## NOTICE TO ALL FIRMS

Date: May 19, 2022  
To: All Prospective Bidders  
From: Sam Li  
Deputy Director of Purchasing  
Re: Addendum Number 3  
IFB # C1544 – Kaufman Hall Façade Repairs

1 PROPOSED SIDEWALK SHED  
 6K-001 SCALE: 1/16" = 1'-0"

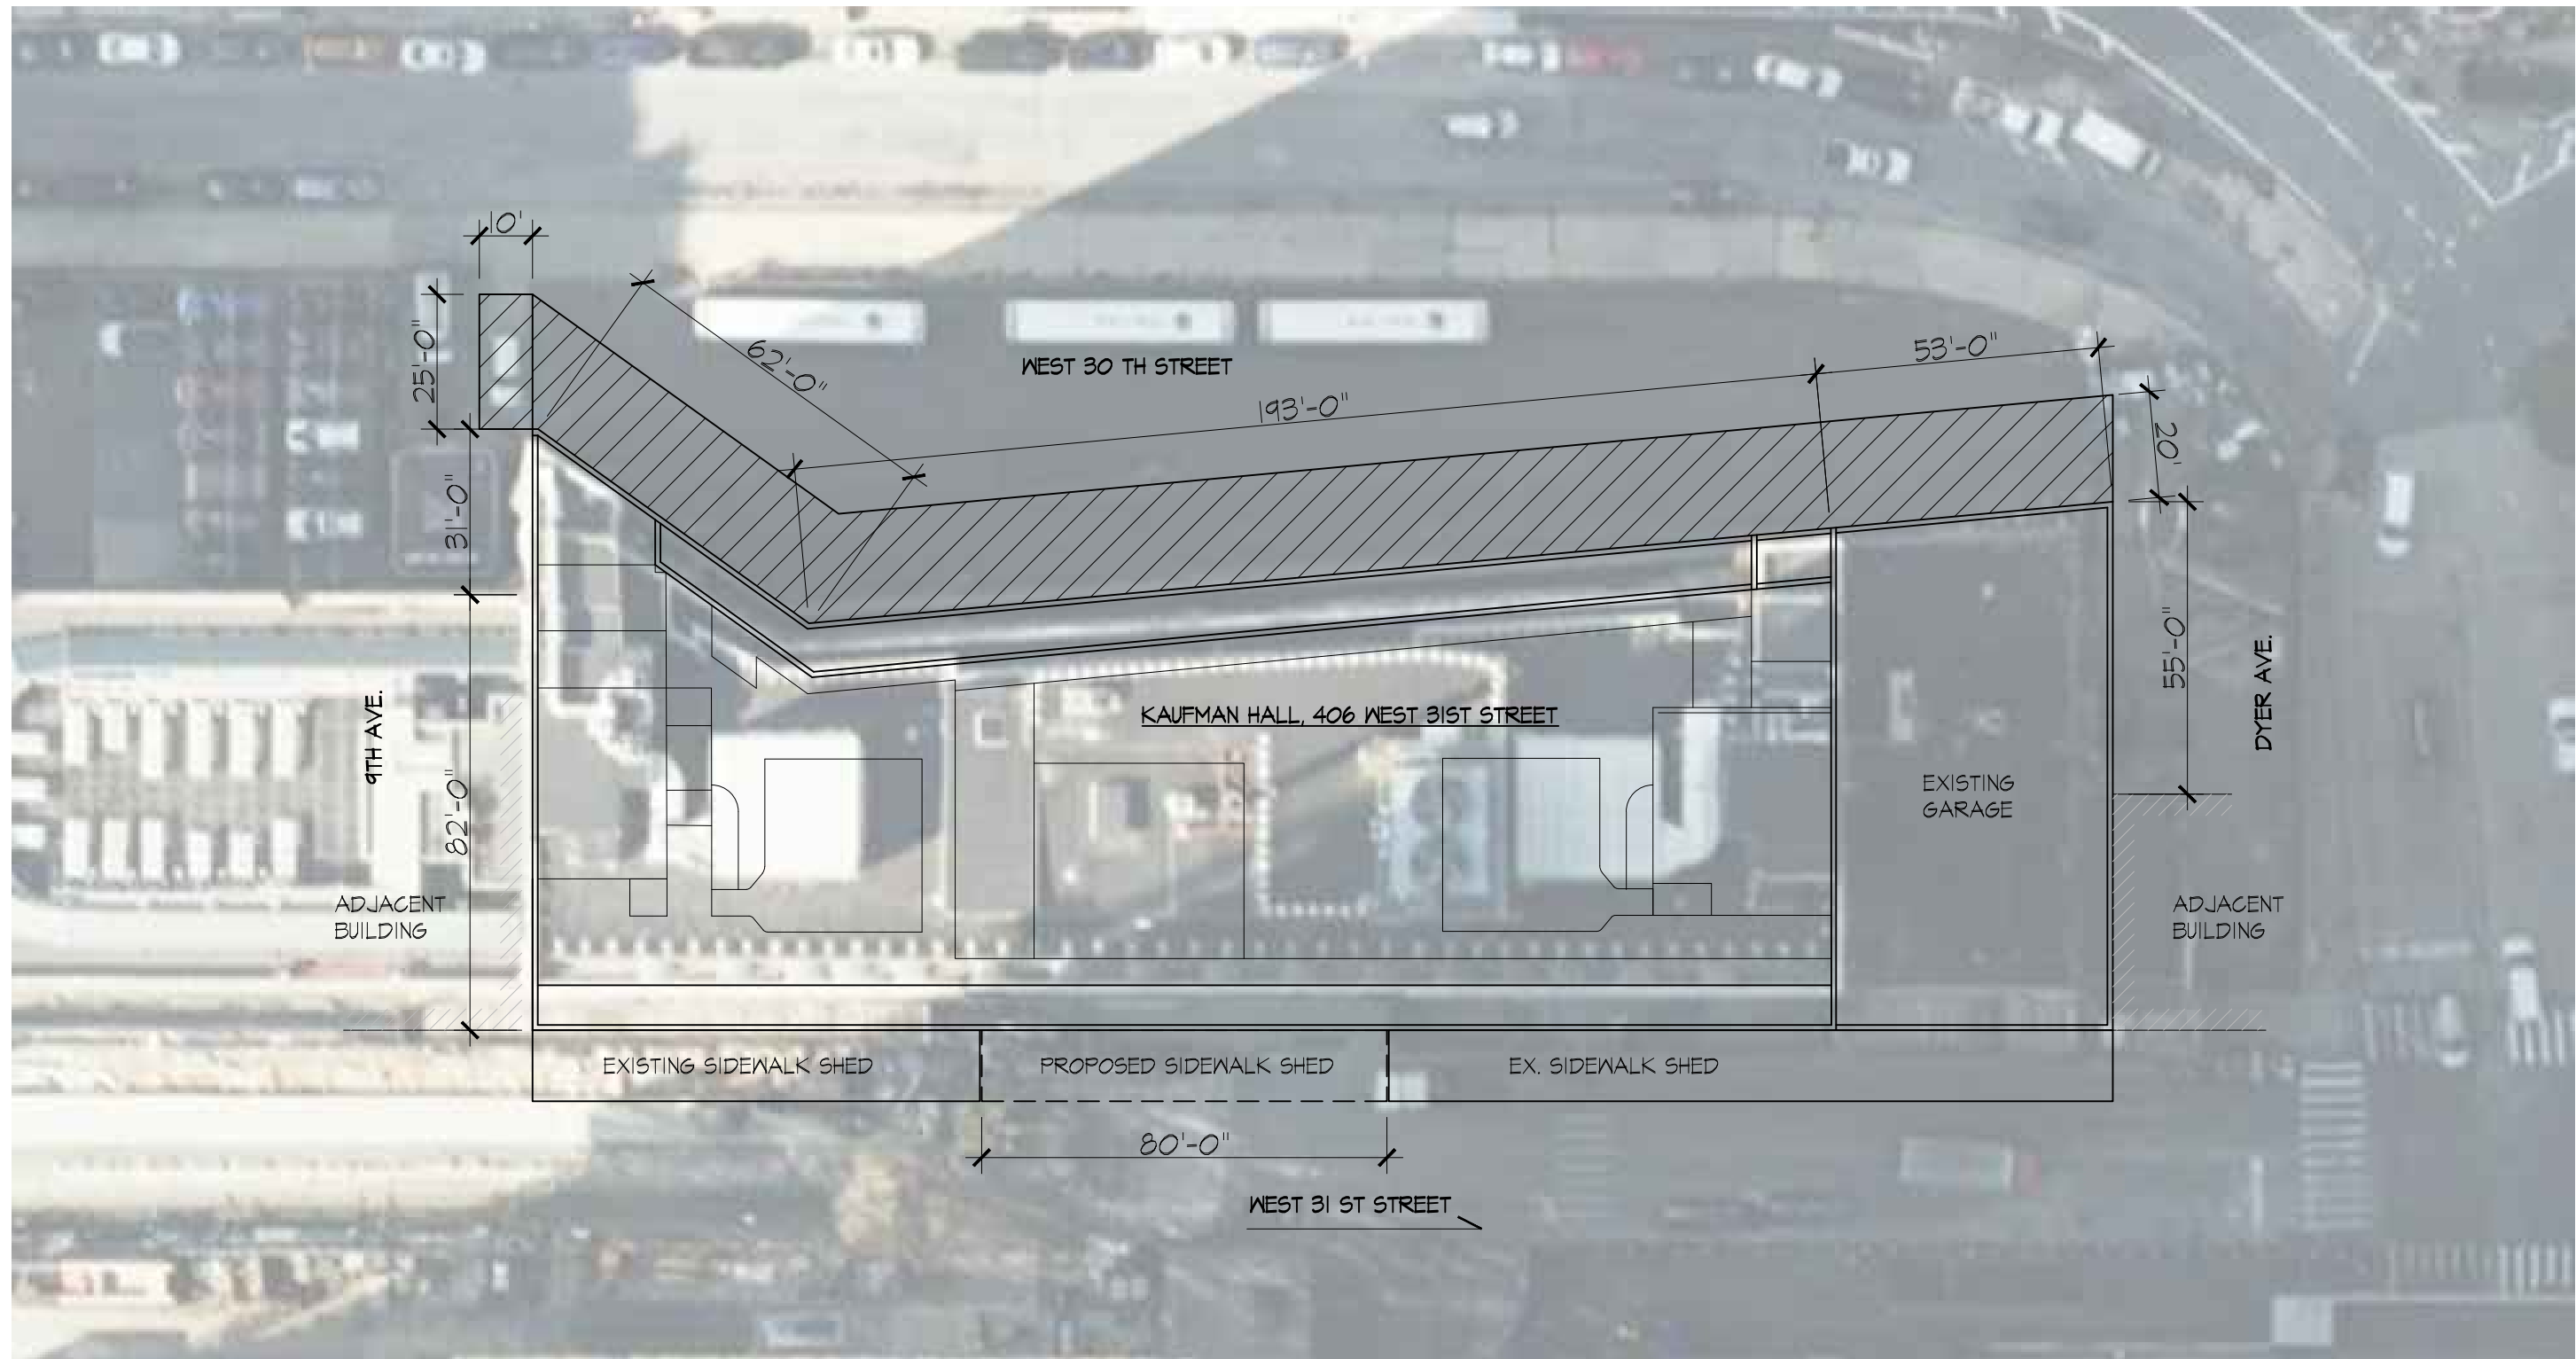
Q1. For questions Q1-Q6, all drawings indicate NTS except A 100.00 it is difficult to scale to measure height of building for all purposes for bidding.

Refer to Bid Form Section I. Part 2 Overhead Protection Bridge Item C. At East and West elevation, there is nothing shown in plan drawing A 100.00. Please indicate how much at east side=----Ft and west side=----FT for pricing

**A1. Please find attached drawing SK-001 & SK 002 showing approximate dimensions. Contractor to Verify in Field. (See attached drawings below)**
